Denver Union Station Redevelopment

Public Presentation on Transit Architecture | July 16, 2009

Public Comment on Transit Architecture

Circulation – Mall Shuttle

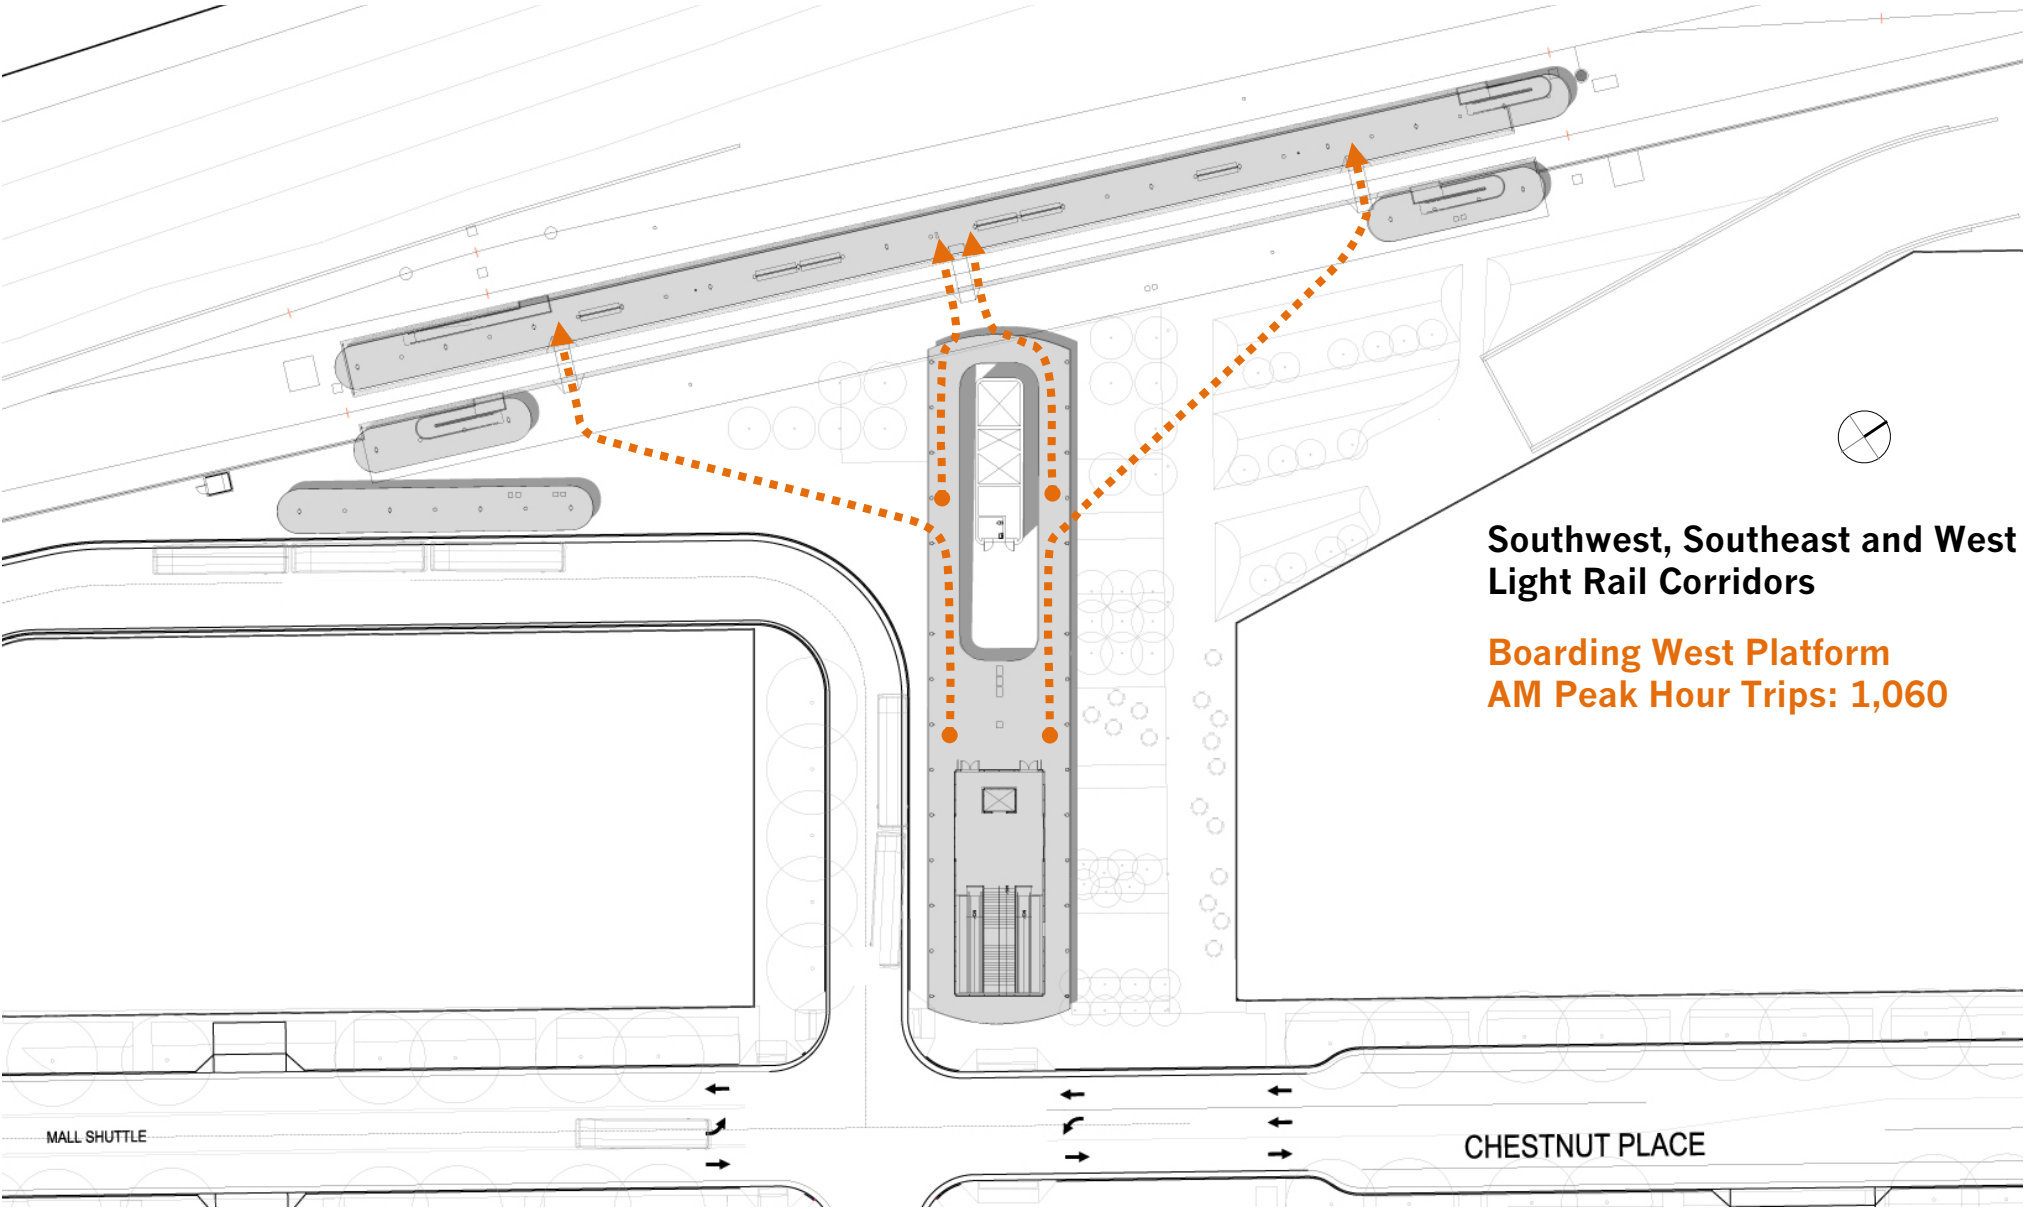
Mall Shuttle Route

- Add more stops for the shuttle.
- Move 16th & Wewatta stop to align with CRT public concourse.
- Add a stop for every block in the CPV, similar to Downtown and LoDo in the rest of the system.
- Extend loop to open up access to north side of the Valley/Prospect neighborhood and enhance access to regional buses.

- Per RTD, changes to the planned route and stops are not contemplated at this time.

LRT Architectural Design

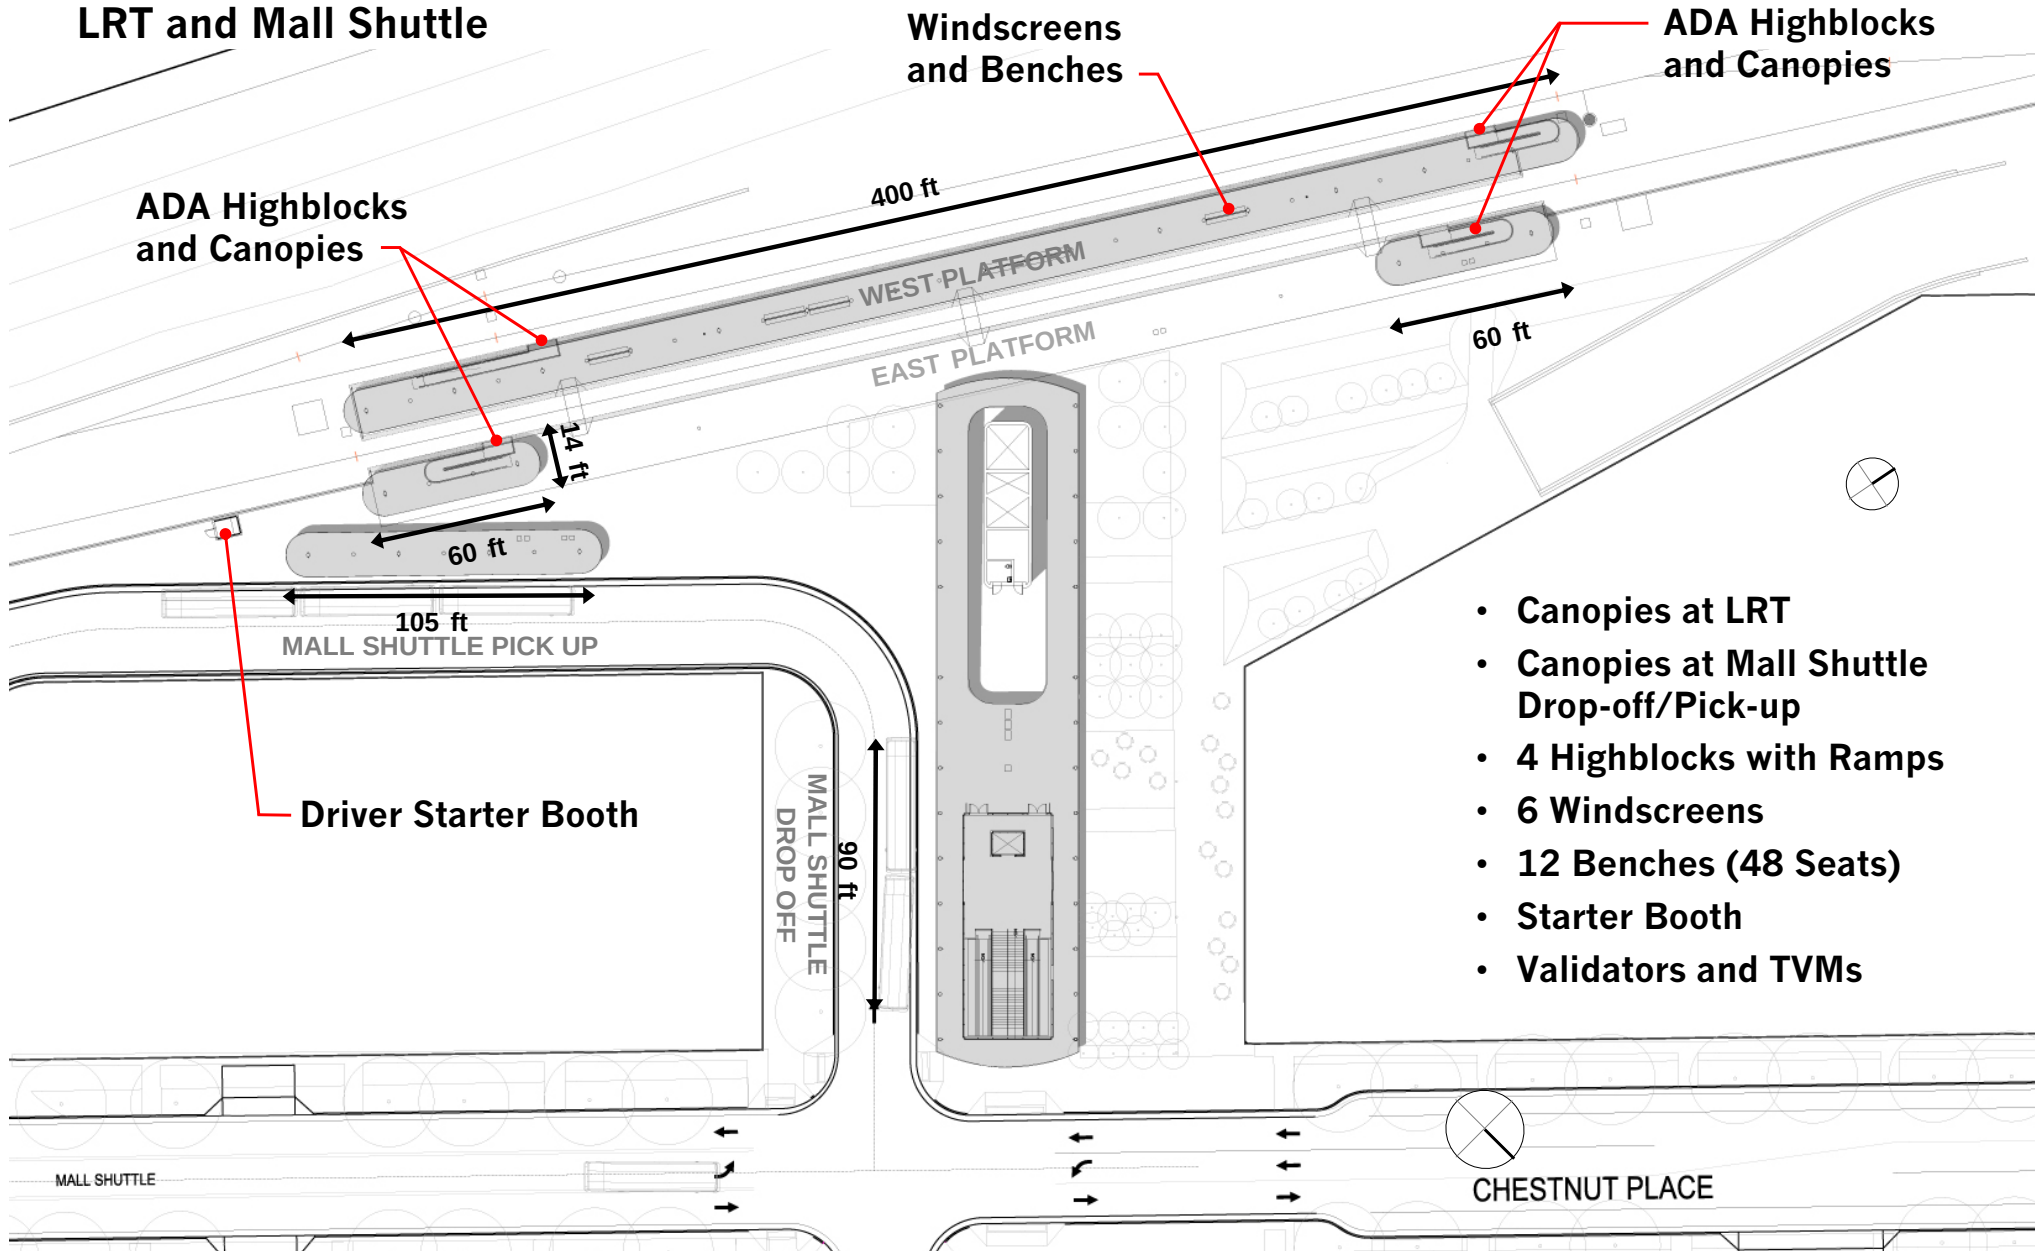
- There has been no public review of any design for the LRT. Is it important that that design be presented to and evaluated by the public.
- To maximize the TOD development opportunities on Blocks 15 & 17, it is important to develop a unique destination place and arrival experience as a transit station.

- Agreed. New presentation material is available.

On-street Parking

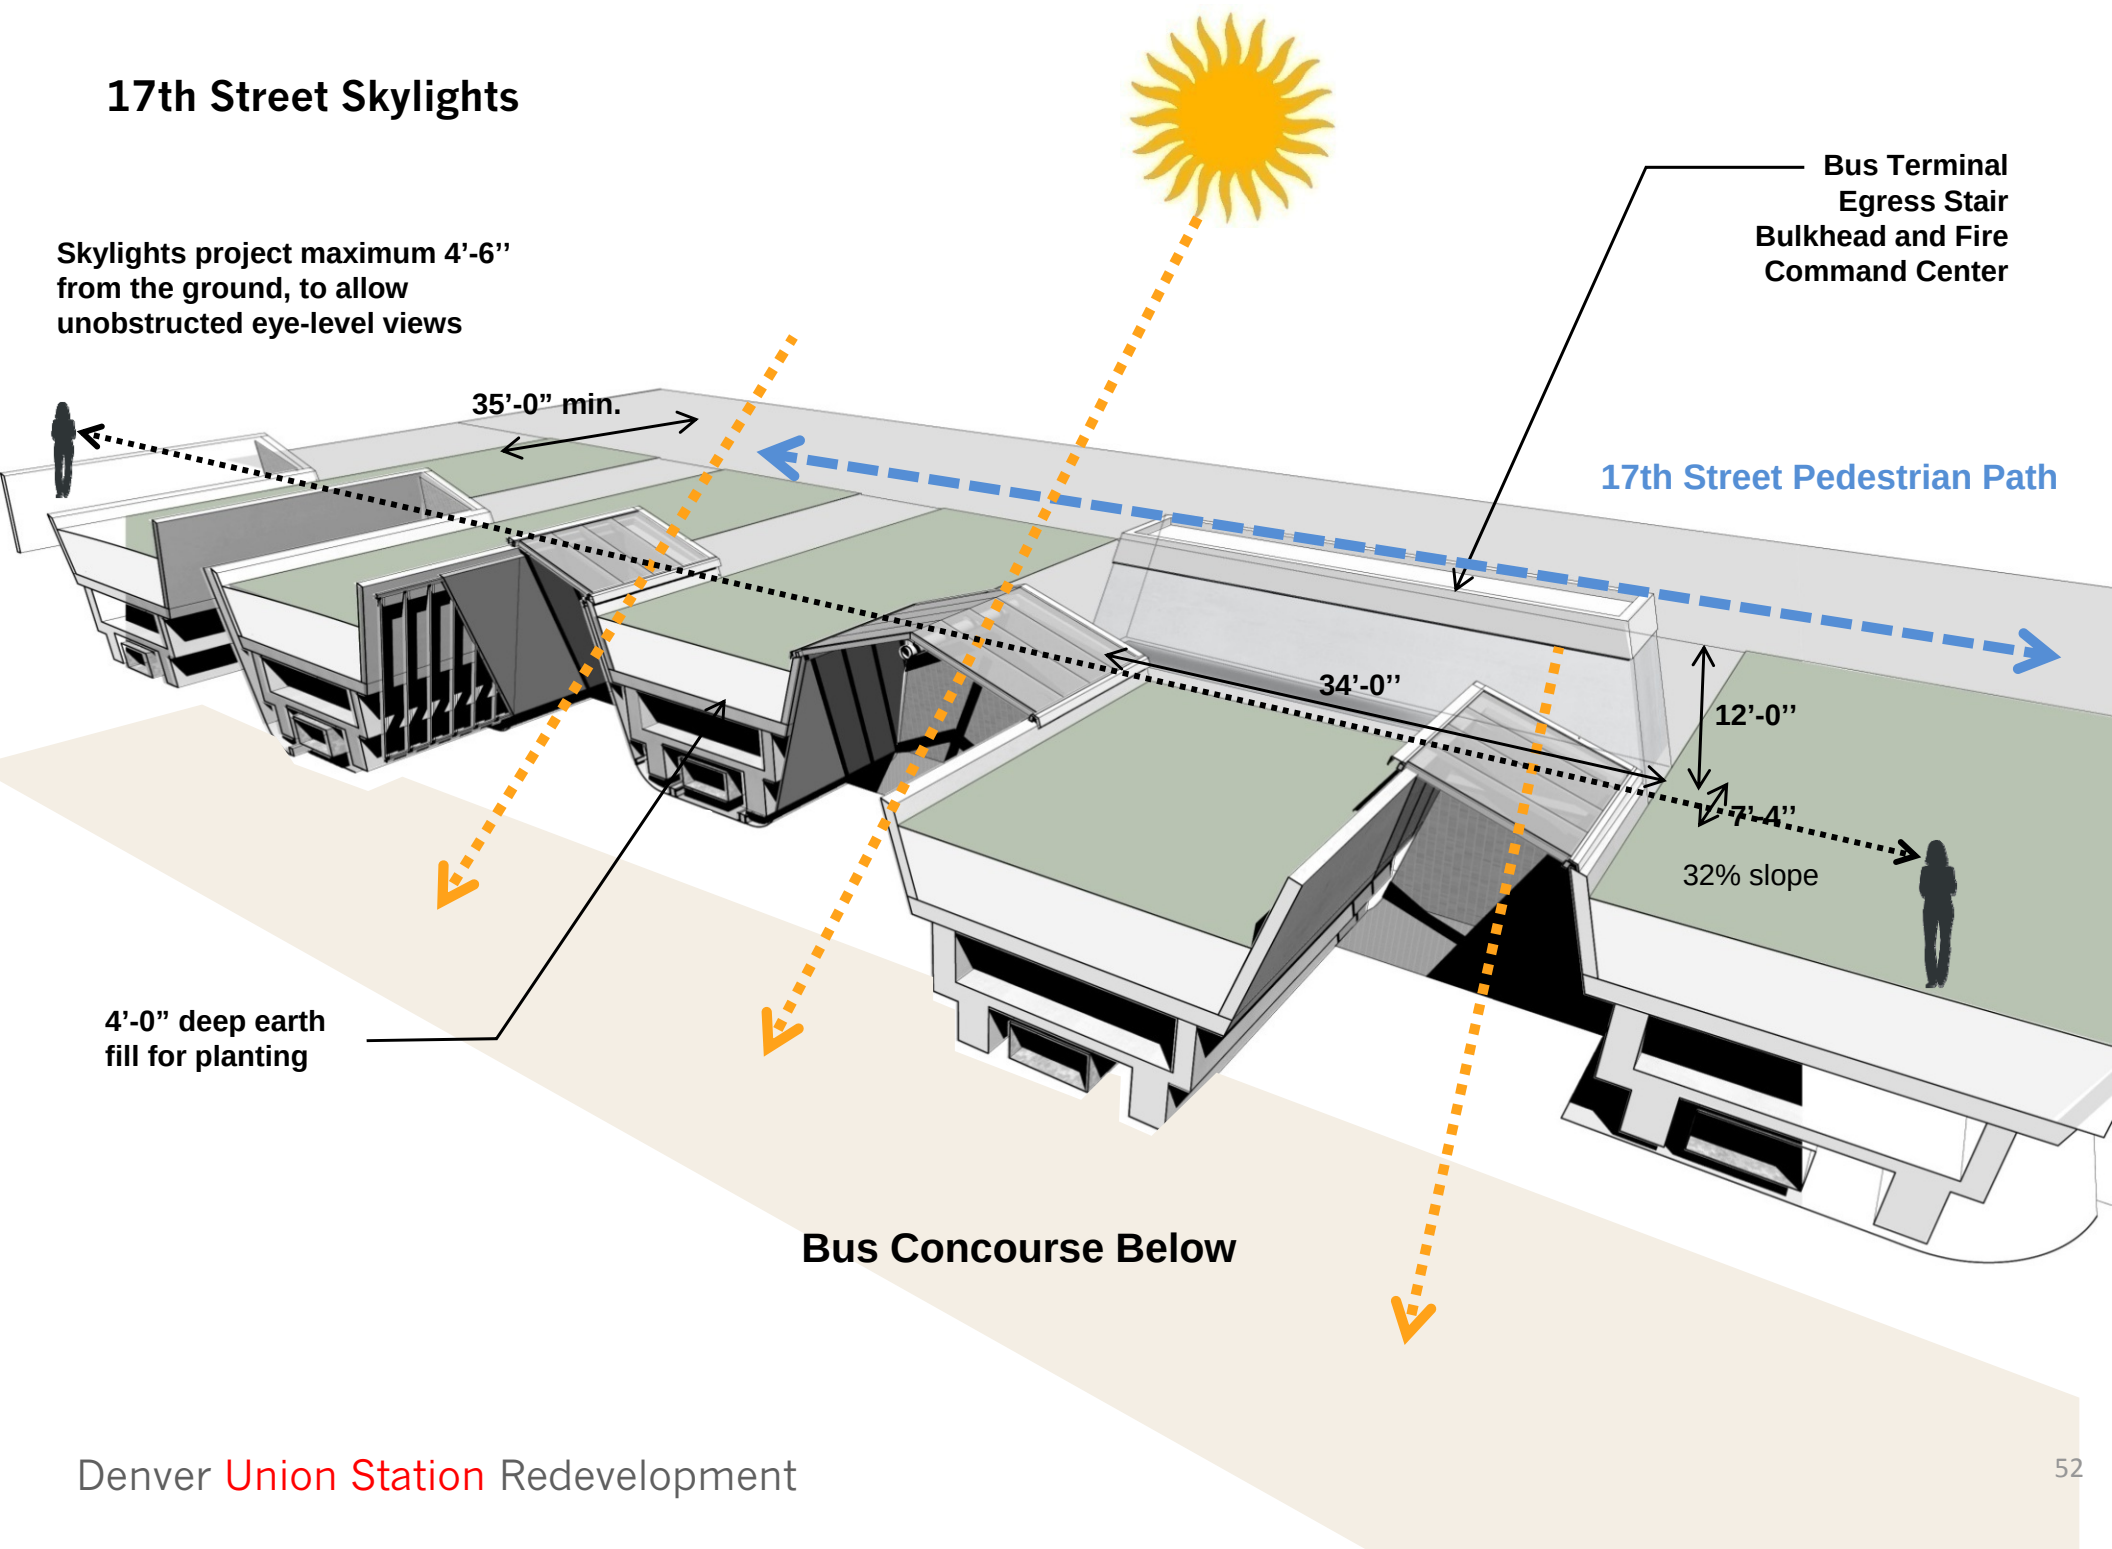
- Delete the northern row of parking in the 17th Street ROW to improve accessibility to the public “rooms” of the 17th Street linear park and to maintain an axial view and walkway to the station.

- Project leadership intends to provide as much on-street parking as possible to support retail.
- Design Team will investigate opportunities to refine the cross-section of the street.

Train Hall Architectural Design

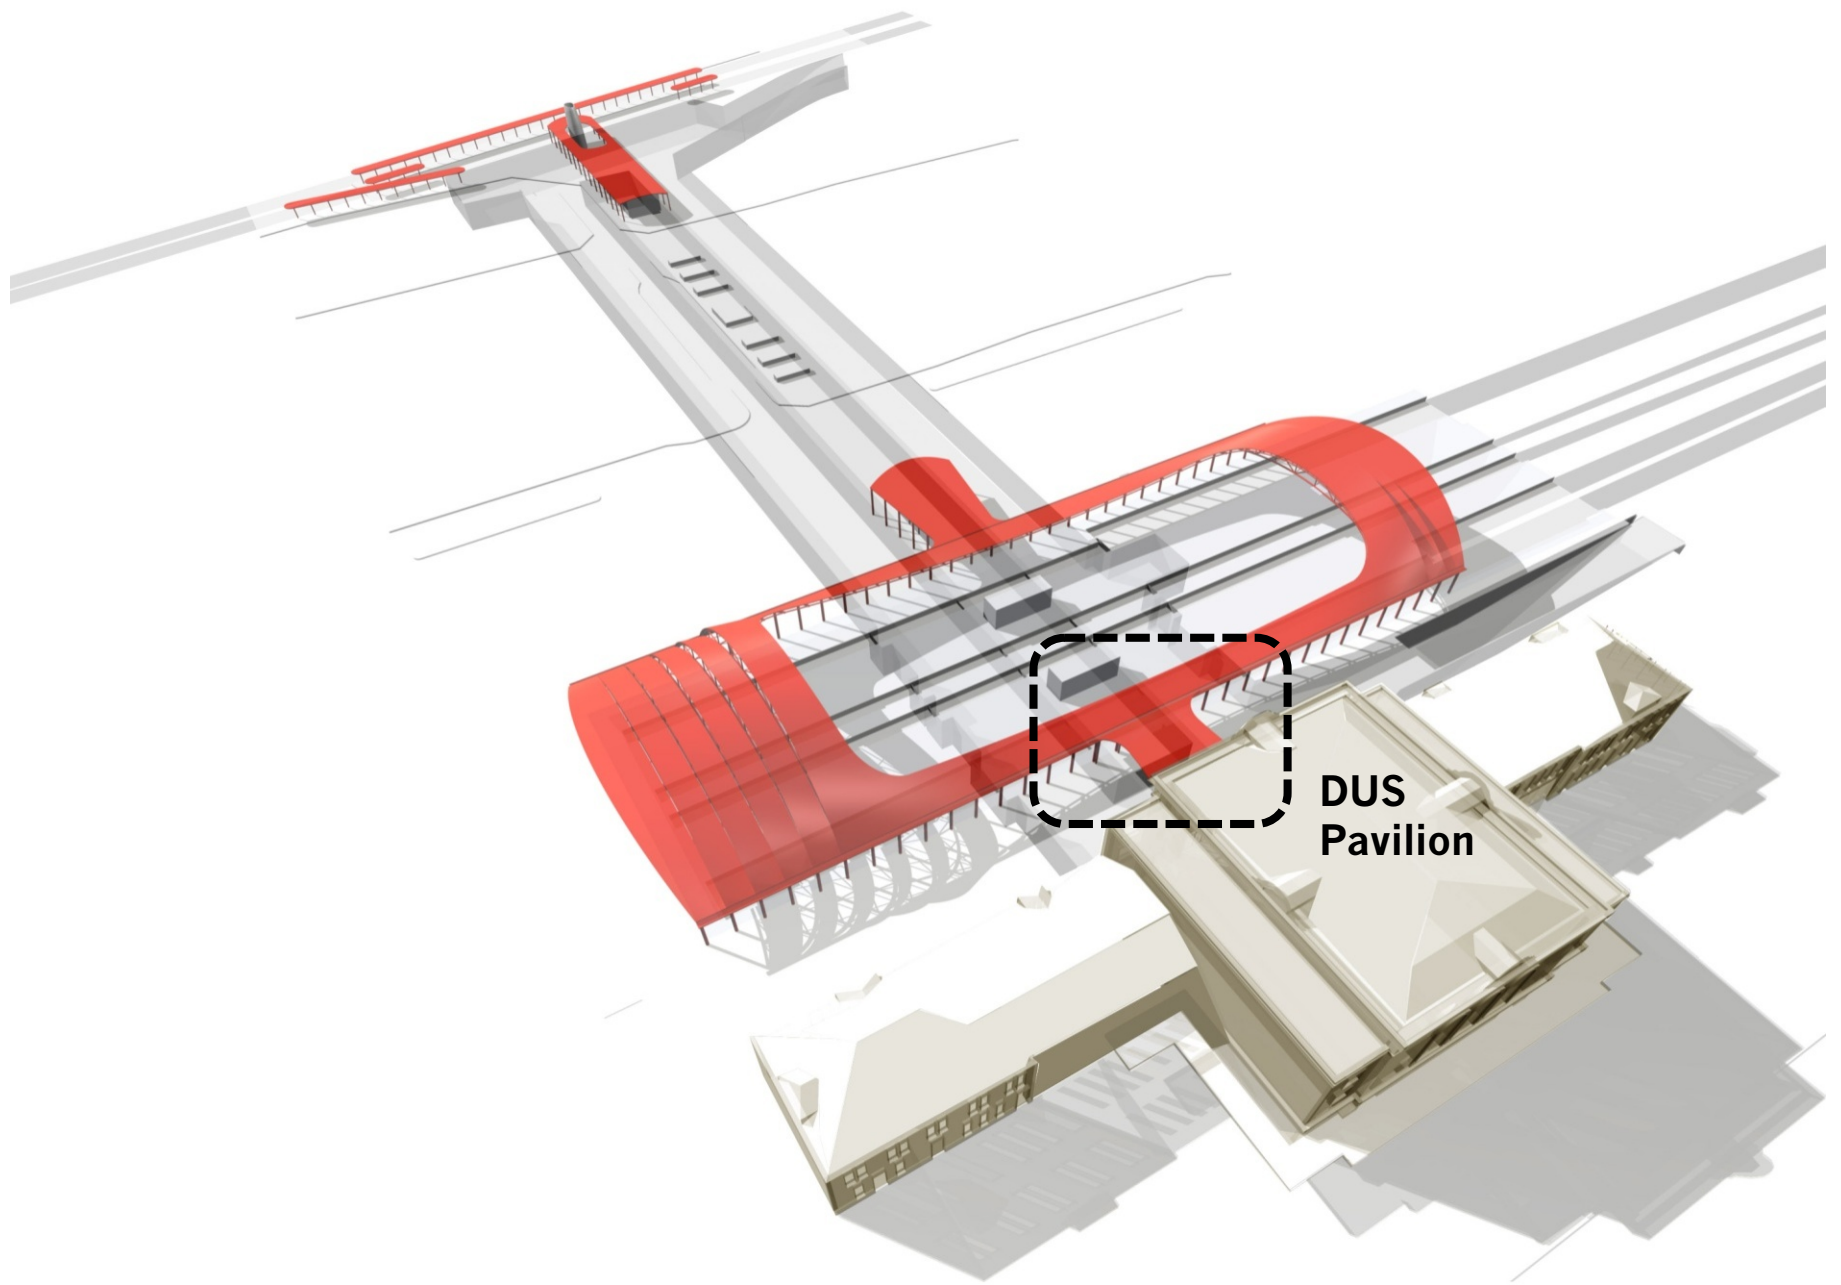
- Most walls (of private development) surrounding train hall are blank walls. This is important problem. How to create pedestrian friendly facades here needs to be looked at carefully.
- It is crucial that the passageway from 16th Street through the A Block building have a real presence on 16th Street. This building functions as a headhouse to the CRT.

- The DUS Urban Design Standards & Guidelines address considerations for the future adjacent mixed-use development.
- DUS wayfinding design will address the concern about intuitive circulation.
